**FORD:**

2011-2016 F-Super Duty

**TSB 16-0087 (Continued)**

Figure 1 - Article 16-0087

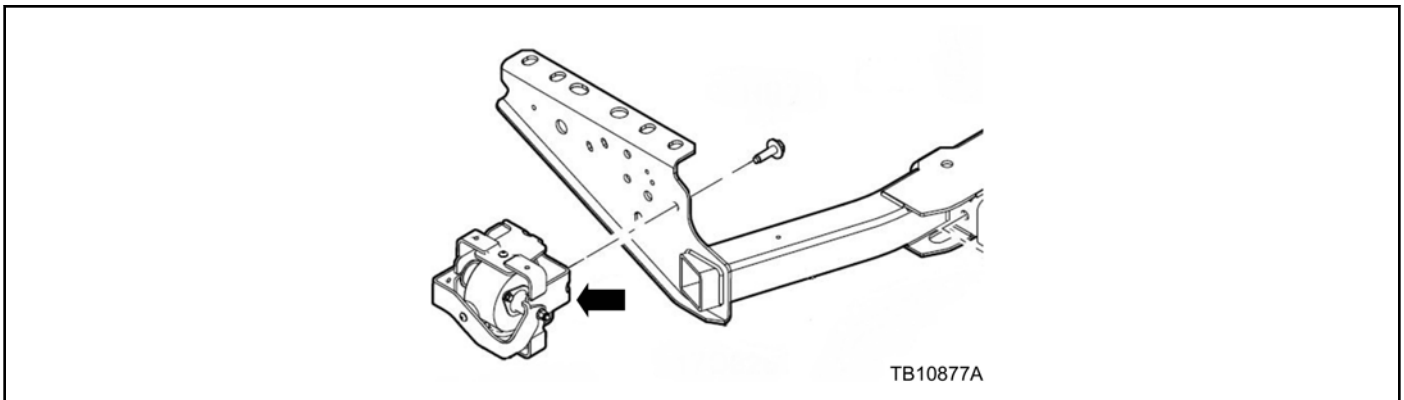
1. Does the customer describe a vibration, which may be described as hopping, at approximately 68-110 Km/h (42-70 MPH)?
  - a. Yes - proceed to Step 2.
  - b. No - this article does not apply. Refer to Workshop Manual (WSM), Section 100-04 for normal diagnostics.
2. Does the vehicle have a cage damper mounted to the factory trailer hitch on the driver side? (Figure 1)

- a. Yes - this article does not apply. Refer to WSM, Section 100-04 for normal diagnostics.
  - b. No - proceed to Step 3.
3. Remove the wiring connector on the driver side of the trailer hitch. (Figure 2)

Figure 3 - Article 16-0087

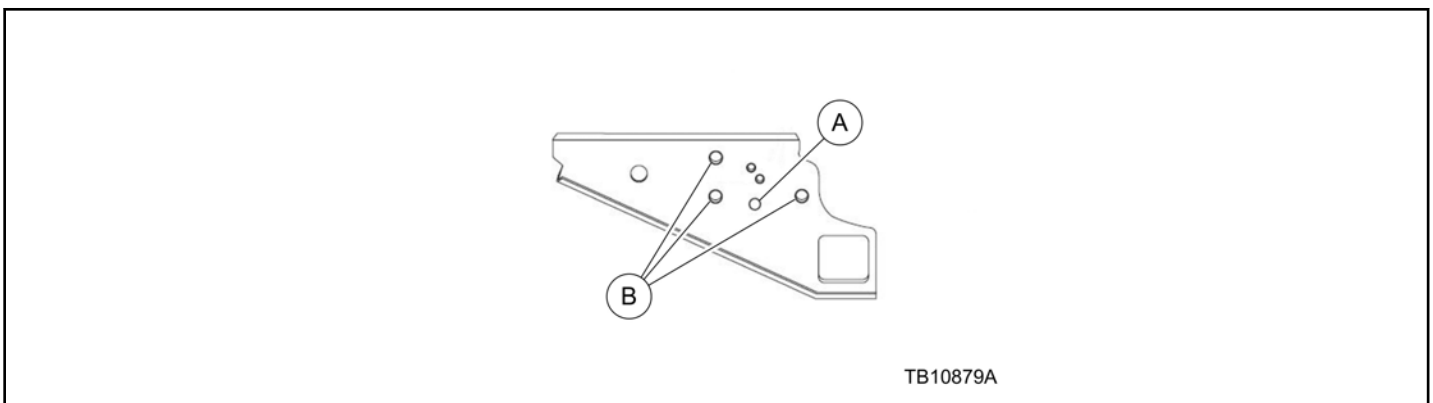
4. Locate in the driver side plate of the trailer hitch the following holes. (Figure 3)
  - a. Clearance hole 17.6 mm (11/16"). The clearance hole will be used for the cage damper rubber pad. (Figure 3A)
  - b. Three mounting holes 14.6 mm (9/16"). (Figure 3B)

Figure 4 - Article 16-0087

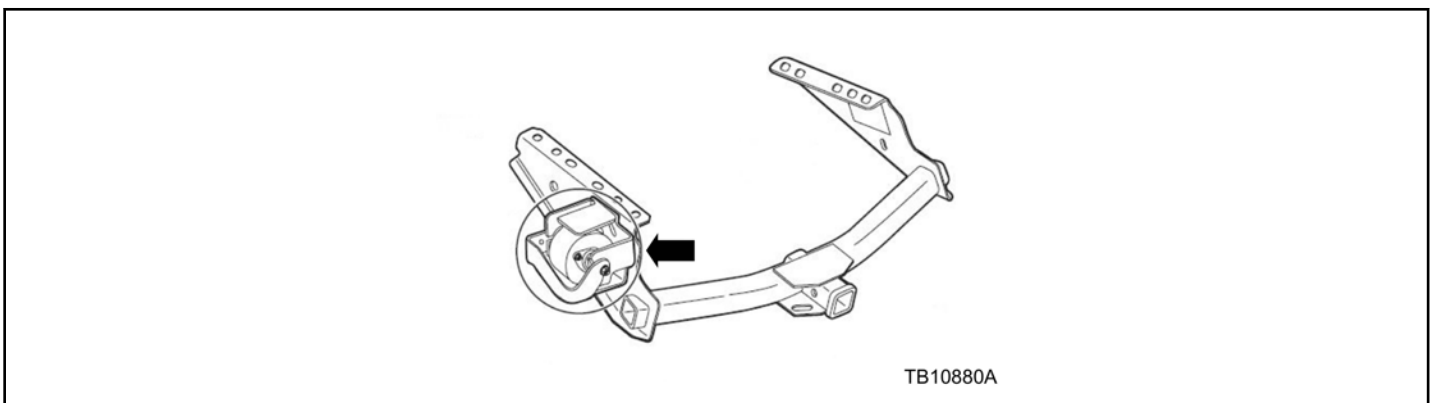
5. Mount the cage damper and install the bolts. Tighten to 63 Nm (46 lb-ft). (Figure 4)
